UNITED STATES PATENT AND TRADEMARK OFFICE

APPLICATION NO	FILING DATE	FIRST NAMED INVENTOR	ATTORNEY DOCKET NO.	CONFIRMATION NO
09 376,063	08 17 1999	SEIJI ANDOH	OKI-226	5971

Office Action Summary

DETAILED ACTION

Fig. 5

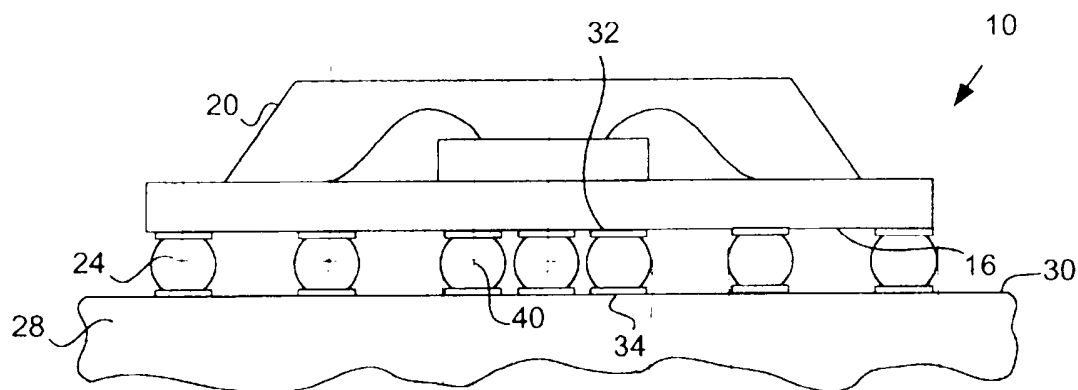
Katchmar teaches a semiconductor device, figs 1-5, comprising: a substrate 12 having a main surface 14 and a back surface 16, wherein said back surface 16 has a central area 32, an intermediate area surrounding said central area 32 and a peripheral area surrounding said intermediate area; a semiconductor chip 18 formed on said main surface; a first bump unit formed of solder bumps 40. Fig. 5 disposed at a first distance

apart from each other, and located in said central area of said back surface, wherein said first bump unit radiates heat from said semiconductor device; a second bump unit formed of solder bumps 24 disposed at a second distance apart from each other and located in said peripheral area of said back surface, wherein said second bump unit transmits signals (col.6, lines 50-53), wherein the second bump unit is greater in quantity of solder balls than the first bump unit, and said solder balls are spherical in shape. Katchmar teaches furthermore a second distance between signals bumps being greater than a first distance between heat transferring bumps (col.7, lines 39-47). Also in the embodiment shown in figs.1-4 Katchmar teaches that said central area could be thermally connected to said circuit board by a solid melted solder mass 26.

Katchmar does not teach that second distance is less than a width of the intermediate area, and said melted solder mass (unitary body) can be made by locating bumps of the first bump unit sufficiently closed to each other that upon the application of the heat treatment to the device, the bumps of the first bump unit fuse into a unitary body. Bond et al teach a semiconductor device 8, figs 1-6, comprising: a substrate 14 having a main surface and a back surface, wherein said back surface has a central area, an intermediate area surrounding said central area and a peripheral area surrounding said intermediate area; a semiconductor chip 10 formed on said main surface; a first bump unit formed of solder bumps 18 disposed at a first distance apart from each other, and located in said central area of said back surface, wherein said first bump unit radiates heat from said semiconductor device; a second bump unit formed of solder bumps 18 disposed at a second distance apart from each other and located in said peripheral area

of said back surface, wherein said second bump unit transmits signals, the second distance is greater than the first distance, the second distance is less than a width of the intermediate area (see fig.1 in the enclosed page from reference by Bond et al with red color indicating discussed sizes), and the second bump unit is greater in quantity of solder balls than the first bump unit, said solder balls are spherical in shape. Bond et al also show in fig.2 bumps 18 of the first (central) bump unit located so closed to each other that upon the application of the heat treatment to the device, they will obviously fuse into a unitary body. It would have been obvious to one skilled in the art at the time invention was made to employ the second distance being less than a width of the intermediate area, and to locate bumps of the first bump unit so closed to each other that upon the application of the heat treatment to the device, the bumps of the first bump unit will fuse into a unitary body as it is shown by Bond et al in the device by Katchmar in order to avoid shortening between thermal and signal solder balls while applying a heat to melt said thermal solder balls in a unitary body, and to enhance heat dissipation by a central group of solder balls. Regarding to the claim 31: Katchmar and Bond et al do disclose the claimed invention except for that "the first distance is about 1 to 1.4 times the diameter of the bumps of the first bump unit, and the second distance is about 1.6 to 1.7 times the diameter of the bumps of the second bump unit. It would have been an obvious matter of design choice to make the first distance about 1 to 1.4 times the diameter of the bumps of the first bump unit, and the second distance about 1.6 to 1.7 times the diameter of the bumps of the second bump, since such a modification would have involved a mere change in the size of a component. A change
